# UNITED STATES PATENT AND TRADEMARK OFFICE

APPLICATION NO.	FILING DATE	FIRST NAMED INVENTOR	ATTORNEY DOCKET NO.	CONFIRMATION NO.
10/820,676	04/07/2004	Trudy Bittner Rosser	2044SP-1	8541

This is a non-final Office Action for application number 10/820,676 Support System, filed on 4/7/04. Claims 1-4, 7, 8 and 14-25 are pending. The text of those sections of Title 35, U.S. Code not included in this action can be found in a prior Office action.

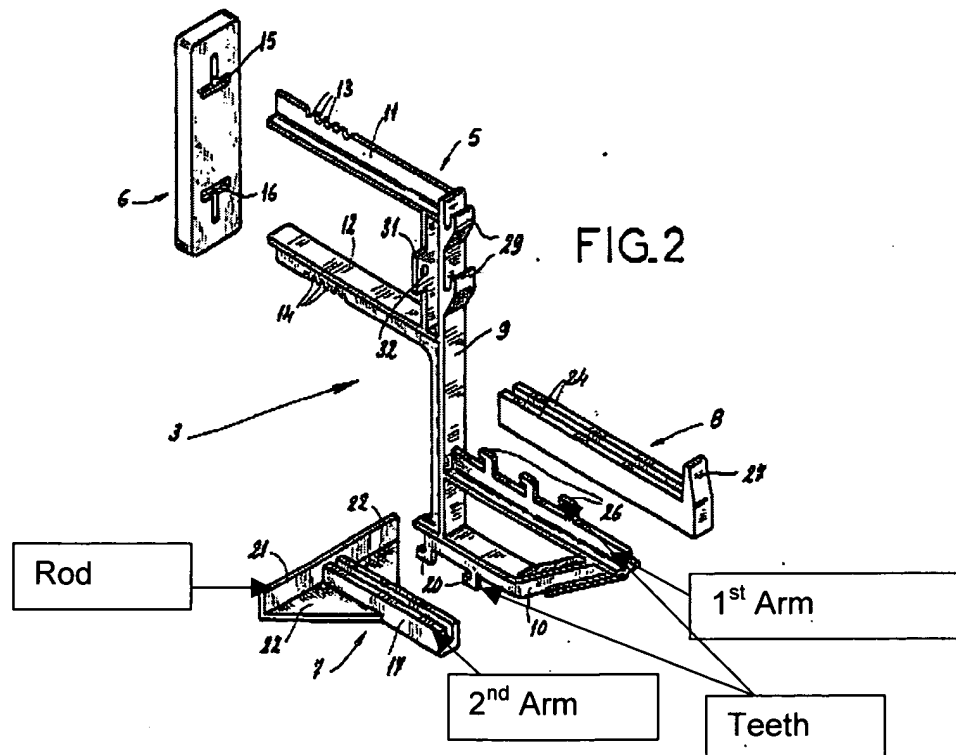
The patent to Lahu teaches a receptacle/box portion (1) having a base and a peripheral wall extending from the base and having an upper end defining an opening, at least one first engagement mechanism (25) integrally formed with the receptacle, a first arm (See Below) having a proximal end engaged in the engagement mechanism and a distal end, at least two second engagement mechanism (20) integrally formed with the receptacle, and a matching plurality of second arms (7) having a proximal end engaged in the second engagement mechanism and having a distal end, wherein the distal end of the second arm is disposed below a position of the first arm and a rod (21) coupled to and extending between the second arms and extending laterally to abut the support wherein the first arm is adjustably engaged by the first engagement mechanism. Lahu also discloses a first releasable locking mechanism (26) positioned within the at least one first engagement mechanism which releasably locks the distal end of the first arm with a ratchet (26 ratchet teeth) on the first arm and a pawl on the

engagement mechanism at one of a plurality of distances from the receptacle wherein the second arm is adjustably engaged by the second engagement which has a releasably locking mechanism (20) the distal end of the second arm a plurality of distances from the receptacle and a scale (the distance in between teeth can function as a scale) marked on the first arm providing an indication of distance from the distal ends of the first and second arms from the receptacle.
